**DURHAM DEVELOPMENT REVIEW**  
**D1500101 Duke University Central Generation Plant #3**  
**LEVEL 3 SITE PLAN**  
**1<sup>st</sup> Review**

SUBJECT: Duke University Central Generation Plant #3 - Review #1  
Case # D1500101 Case History:  
PIN: 0811-05-69-9253  
Address: 2100 Duke University Road (Wannamaker Drive)

LEVEL 3 SITE PLAN  
CASE NUMBER: D1500101  
JULY 14, 2015  
SECOND SUBMISSION

G-001

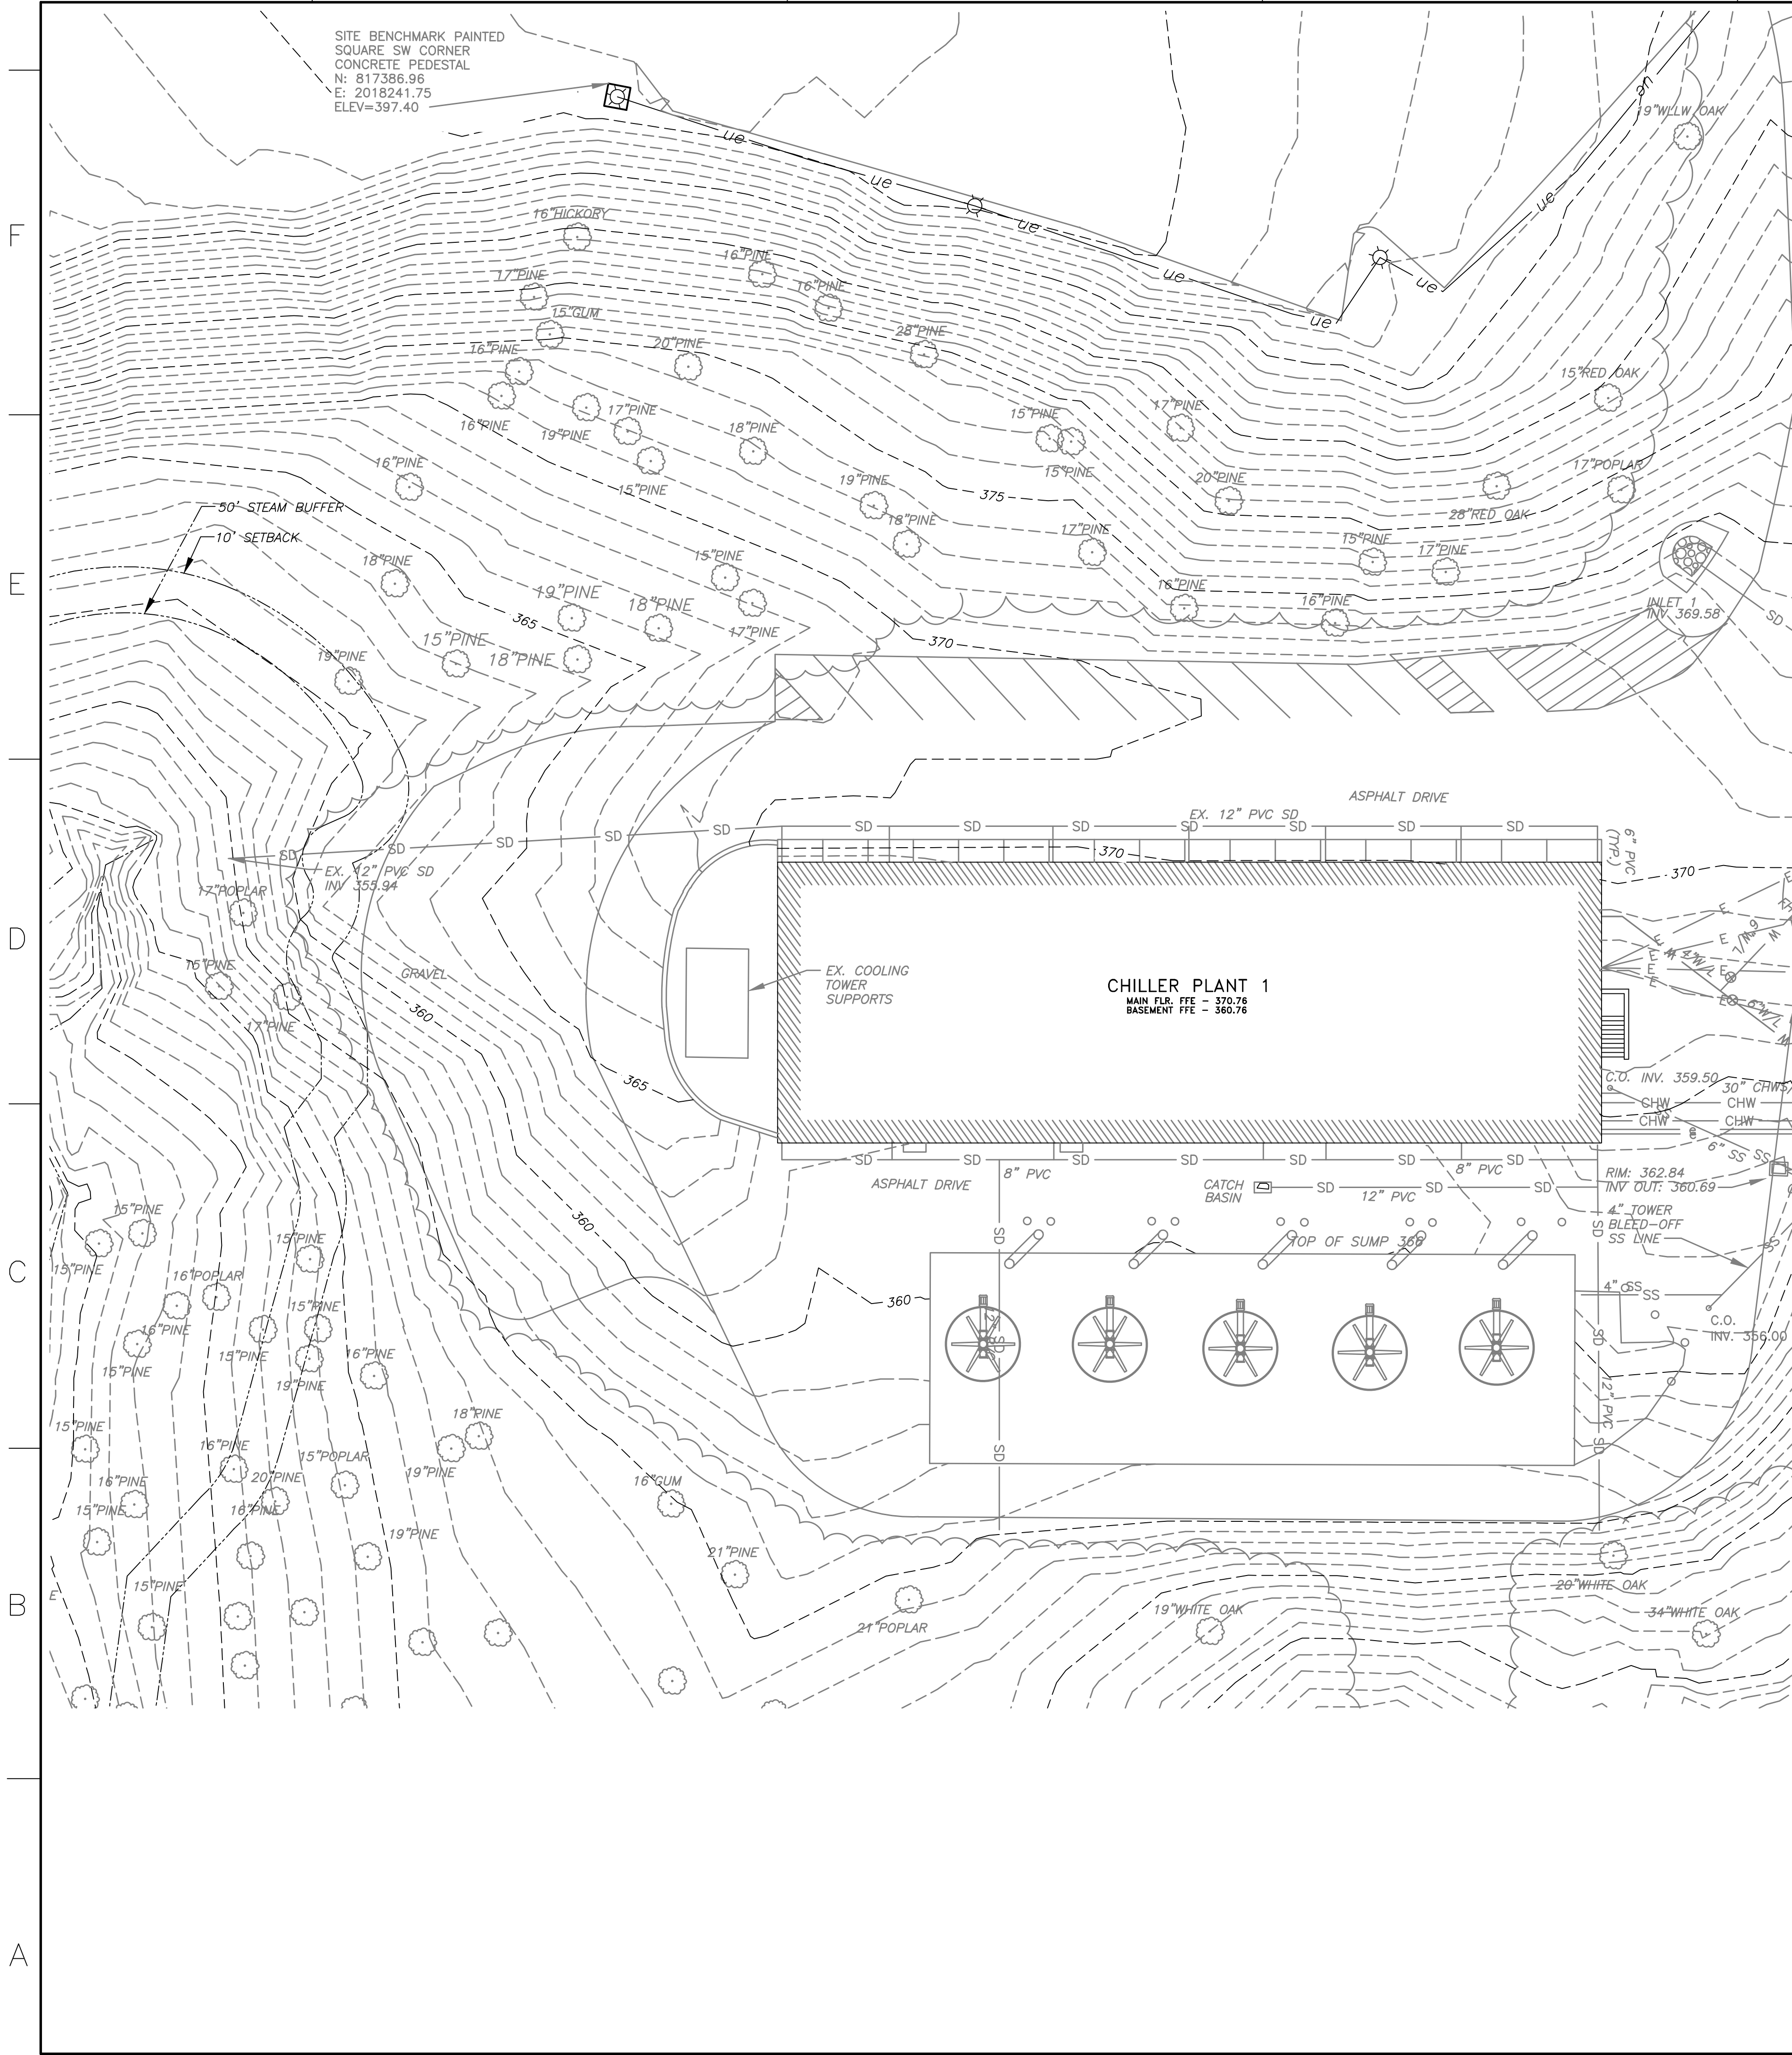
1. Add the planning department case number D1500101 above the approval stamping area, per the requirements of the site plan checklist.  
**RESPONSE: Planning department case number has been added on G-001.**

2. Per the requirements of the site plan checklist, place this note in the Special Conditions of Approval Box: Owner/developer shall notify the Durham City County Planning Department Site Compliance staff at the completion of construction and landscaping to request an inspection prior to use of the facility.

**RESPONSE: New Generator has been identified and dimensioned on C-201. Generator is 12' from edge of building.**
4. Per UDO section 8.3.1.B.3, No tree coverage is required in non-residential districts in the urban tier, please revise the required and proposed tree coverage shown in the site data table on the cover to “N/A”.

**RESPONSE: Note has been added on G-001.**
3. Show the dimension of the new generator from the existing building per the requirements of the site plan checklist.

**RESPONSE: Site Data Table has been updated to remove tree coverage requirements on G-001.**
5. Enlarge the notes on the tree protection detail, shown on sheet C-401 so that they are legible.

C-201

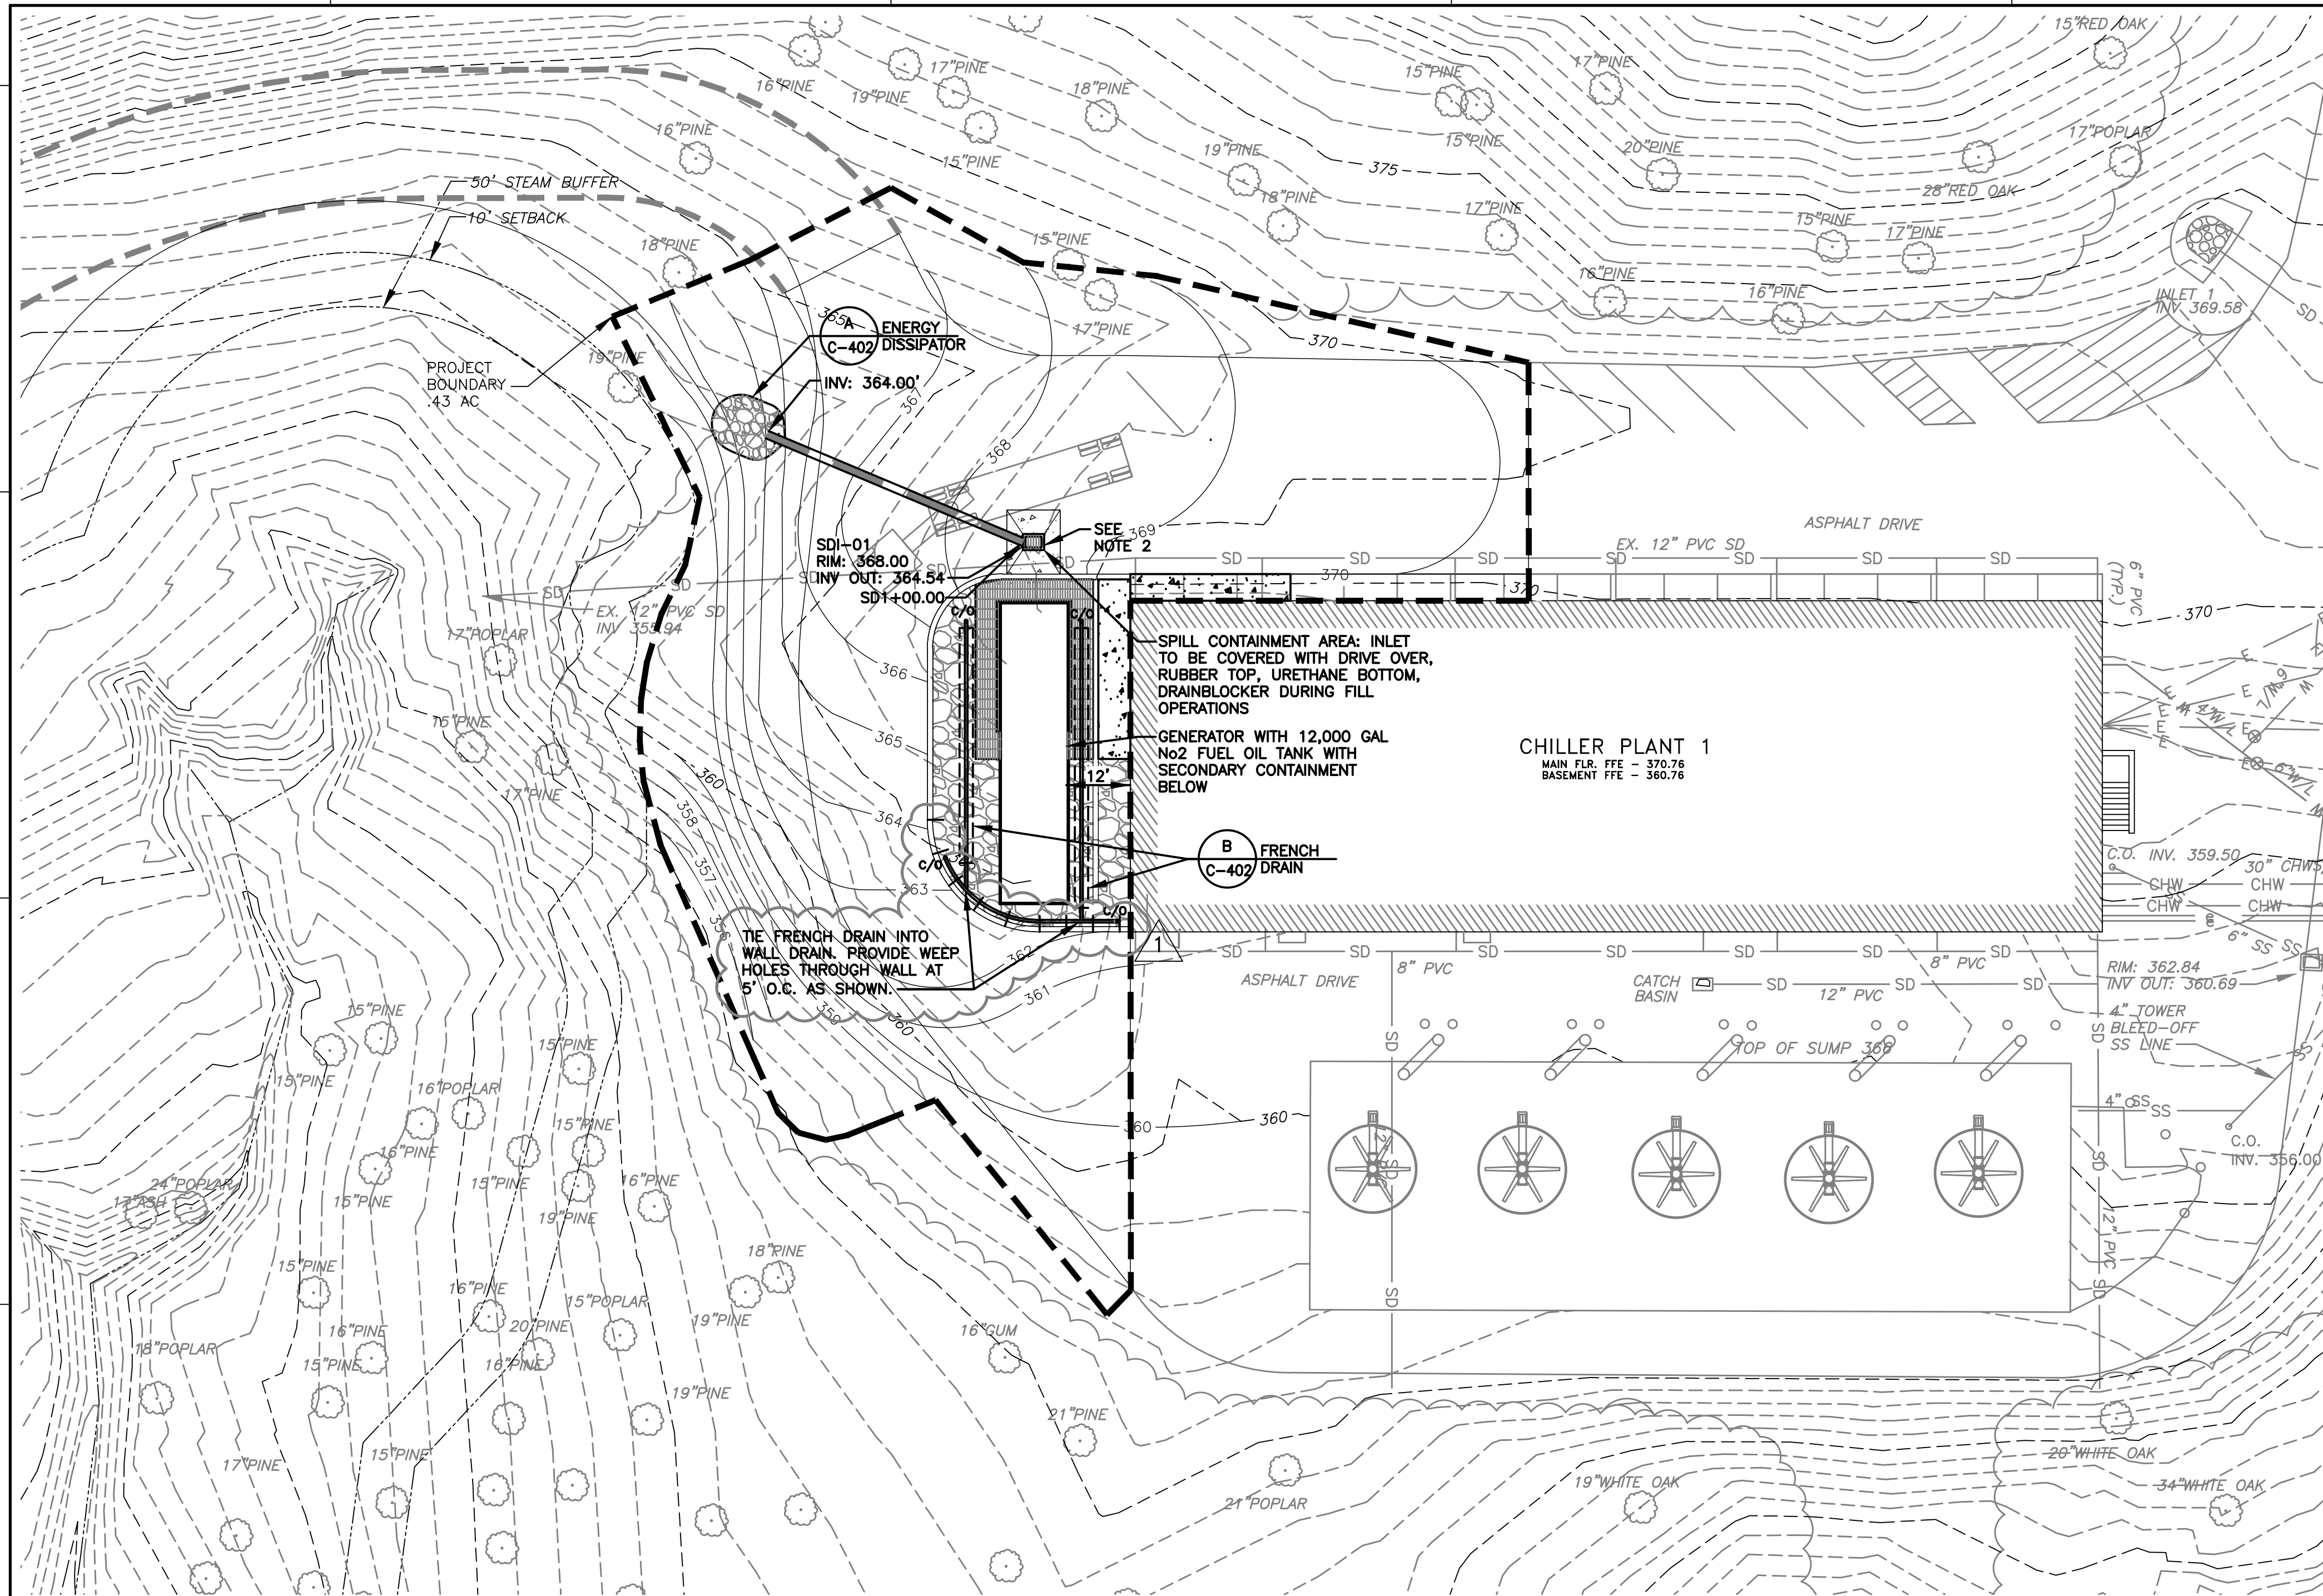
8. On the Site Utility Plan, please indicate where the wall drain discharges to. I believe we talked about this at a meeting and the wall drain is essentially like a weep hole that releases water to the pavement, whereupon it just sheet flows across the pavement. Please indicate this on the drawing.

**RESPONSE: Drainage exits through the wall through weep holes and sheet flows across the pavement. Weep hole locations have been called out on C-201.**
